# Project Information

**ADDRESS** 550 Mercer St

**SDCI #** 3039269-LU

# Response to EDG

# EDG - Massing

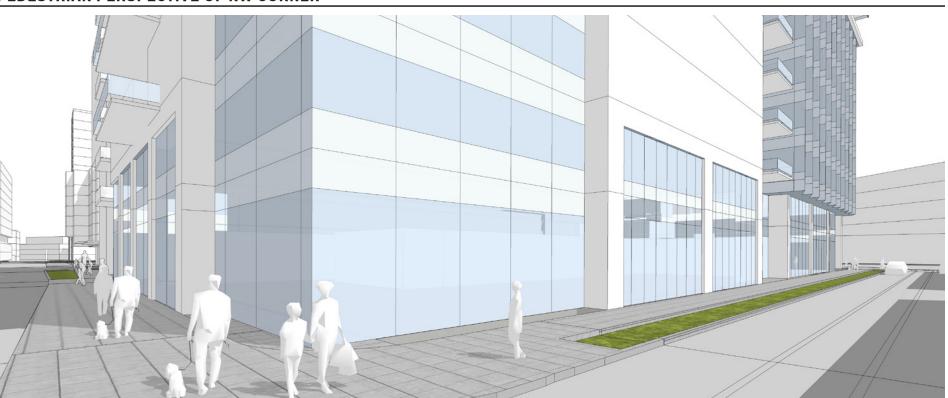
Although the Board supported the carving of the lower levels at the corner of the mass at the northwest corner, the Board discussed whether the 4-story proportion was an appropriate transition between the more active area of the neighborhood to the east and the more pedestrian character that is found to the northwest of the site. The Board gave guidance for the applicant to study alternative heights and proportions of the carved corner to potentially better relate to the more intimate pedestrian character and scale found nearby. (CS2-C-1, CS2-3-A, PL2-A-C, PL3-C, DC2-C, DC2-3, DC2-4)

- The design team revised the massing and facade expression with two major factors in mind. The first major factor, was responding to the context by further breaking down the massing at the northwest corner to better react to the pedestrian scale around the site. The second major factor, was finding a creative massing solution to allow the incorporation of a single power pole and its required setbacks. With these factors in mind, the design team studied two solutions for the massing expression:

- <u>Study 1:</u> Explores a <u>setback</u> on the northwest corner for all stories above level 3. This option accomplishes the desire to further break down the scale of the corner and accommodate for the power pole setback, but it does not offer any good solutions at the ground level to benefit the streetscape.

- Study 2 (Preferred): Explores the same setback shape described above, but instead, carries it the full height of the building. This is not required by SCL, and the design team felt strongly that including a voluntary ground level setback that is 28'-9" wide by 12' deep helps to establish a cohesive massing move that offers a new pocket of enhanced streetscape. This relates more directly to its context by establishing a shared language with the Citizen Cafe and by providing usable outdoor space that encourages street level activation.

#### FACADE EXPRESSION TYPE A - RHYTHM & DEPTH DIAGRAM

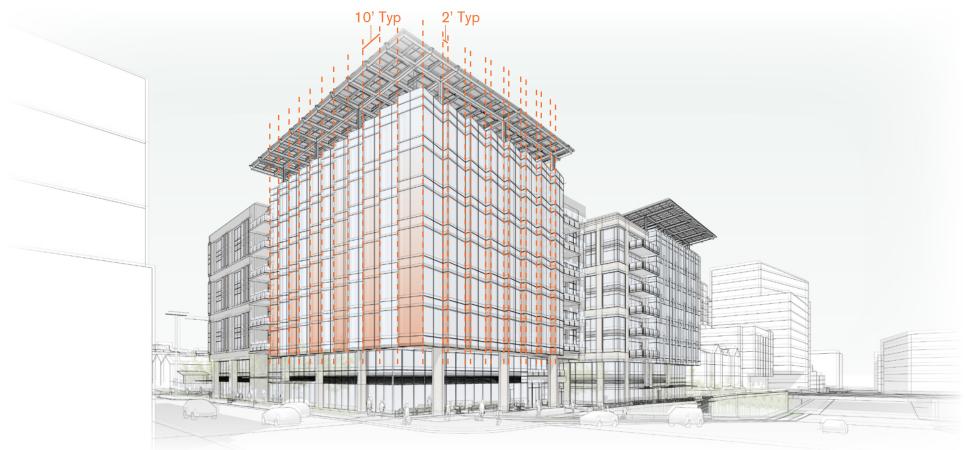
- The board generally supported the facade and pattern concepts and precedent imagery shown on pages 54 and 55 of the EDG packet. The Board specifically appreciated the saw-tooth faceted treatment at the corner of Mercer St and Taylor Ave, and the use of high-quality materials over large expanses of the building facade, such as curtainwall, brick masonry, glass railing, and recessed window groupings. Moving forward, the Board recommended that the applicant continue to develop each facade and provide more information on the detailing of those materials and transitions, showing the material quality, texture, and depth implied in the EDG packet. (DC2-B-1, DC2-C, DC2-3, DC2-5-H, DC4-A-1, DC4-1)

- The **Board recommended** that the applicant continue to **study** the façade design within the carved portion of the mass at the northwest corner to provide a better contextual response to the smaller scaled **residential character** near this corner of the site. The Board gave guidance to study incorporating overhead weather protection and other elements into the façade to provide a well-proportioned composition that works with the scale of the building and enlivens the pedestrian experience. (PL1-B-2, PL1-3-c, DC2-B-1, DC2-C-1, DC2-5-h)

- In order to further refine design expression Type A, which includes "The Pitch", the design team expanded their contextual analysis to include existing and proposed facade rhythms and modules in the vicinity.

- The Lumen Condos, located to the west of the site, has a
  prevalent window opening rhythm and exterior material
  patterning. The primary spacing appears to be between 10-12'
  in width, with secondary spacing being between 2-3' in width.
  Additionally, the building includes projecting balconies that help
  reinforce this rhythm.

- Interval I (570 Mercer) also provides an important precedent.
   The South and Southeast facing facade expression is wrapped in a lightweight glass expression with a recurring pattern of exterior vertical glass fins. This pattern is governed by a primary spacing of 20' and a secondary spacing of 10'

- Therefore, "The Pitch" adopted a rhythmic & modulated pattern that worked to incorporate these adjacent primary and secondary spacings into the facade design.

# EDG - Ground Level - Mercer Retaining Wall

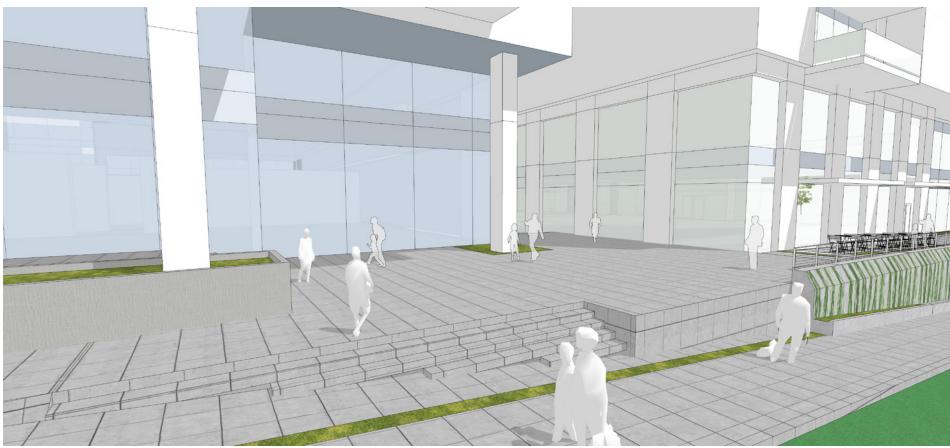
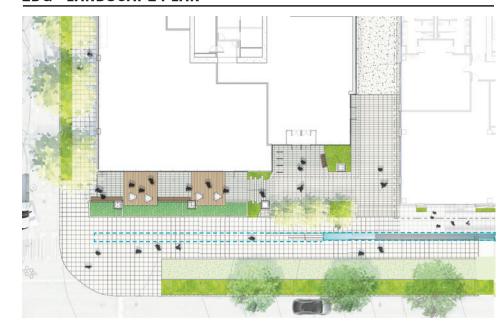
The Board appreciated the implied extensive breakdown and deconstruction of the Mercer St retaining wall and noted how that will allow for increased porosity into the site and will support the successful mix of retail and office/lobby experience at the ground-level along the proposed plaza and open space. The Board recommended that this aspect of the design be retained moving forward and that the open space design should consider circulation and continue to incorporate passive and active uses to promote activity and interaction. (CS1-C, CS1-II, CS1-III, CS2-B, CS2-C, CS2-II, CS2-III, PL1, PL1-I, PL1-IV, PL2, PL4-A)

- The erosion and deconstruction of the existing Mercer Street wall has been developed to change the experience of pedestrians and building users across the entire frontage.

- Along the **Southwestern corner**, the first two levels have been setback to create an arcade with pockets of outdoor seating along this retail edge. This level is slightly raised from the sidewalk and is separated by a mix of bioretention & regular planters that have been located below a series of column covers with an artistic backlit & laser etched pattern.

- Along the **Southeastern corner**, is the publicly accessible plaza space that pulls pedestrians and building users from all directions. A small set of stairs transitions the grade change and cleanly terminates the existing retaining wall while also opening up the sidewalk to pedestrian access.

#### **EDG - MERCER CONNECTIVITY DIAGRAM**

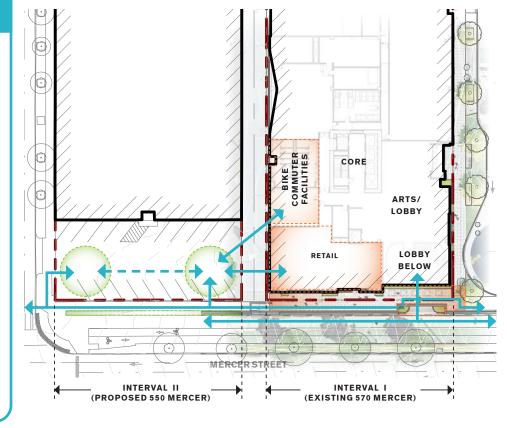
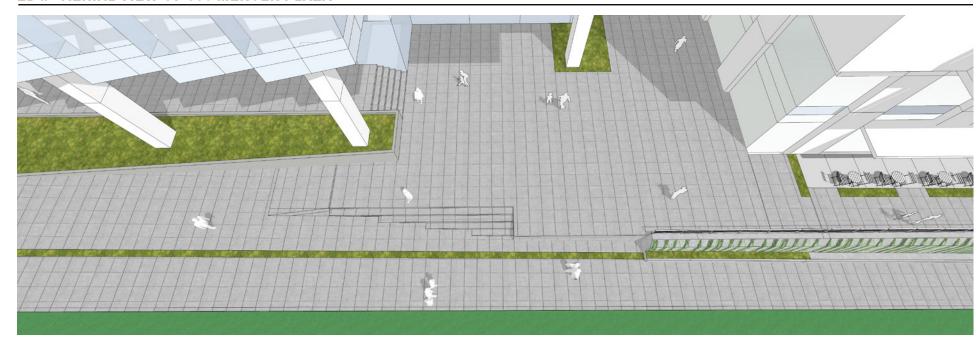
- The Board discussed the importance of **connecting** the proposed **open space along Mercer St with the plaza** approved as part of the 570 Mercer St development across the alley to the east. In agreement with comments provided by Seattle Department of Transportation (SDOT), the Board recommended that the applicant **continue to develop the open space design**, in consultation with SDOT, to **include changes in paving** and some form of **physical barrier**, **architectural or substantial landscaping at the end of the alley to prohibit vehicles from traversing the entire length of the alley. (CS2-1, CS2-3-a, PL1-A, PL2-B-3, DC1-B-1, DC1-C)**

- In conjunction with item 2.b. above, the Board recommended the applicant study including a small boutique sized retail space that could potentially enhance and increase activation of the northeast corner of the open space and lobby entry along Mercer St. (PL3-A, PL3-C, PL3-4-a)

#### **VIEW FROM TAYLOR & MERCER FACING NORTHEAST**

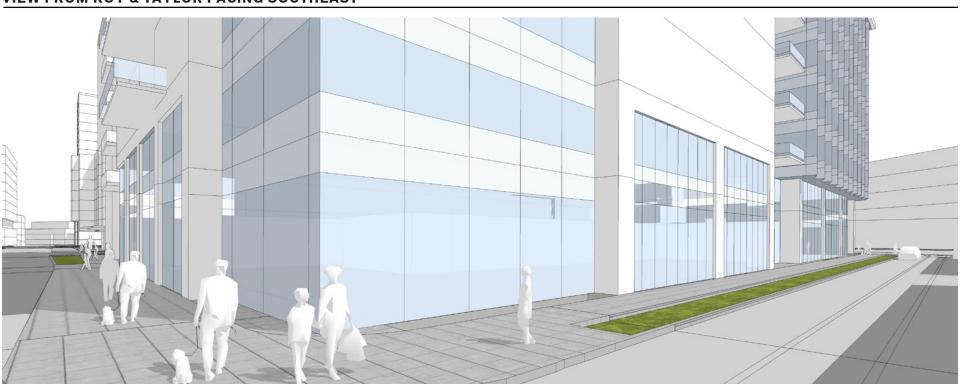
The Board appreciated the applicant's goal of incorporating community inspired art into the design of the building facades and other components. The Board recommended continued study of adding murals that can be seen and experienced from between the site and adjacent buildings, and bring in visual arts as an integrated component of the façade design. (DC2-1-a, DC2-2, CS3-1)

The proposed design will provide for a range of artistic expressions and installations in several key areas around the site. The locations were prioritized to be in the most highly trafficked areas at ground level to ensure they are highly visible. The design team worked closely with the **LURC** to incorporate their suggestions into the types and locations provided below.
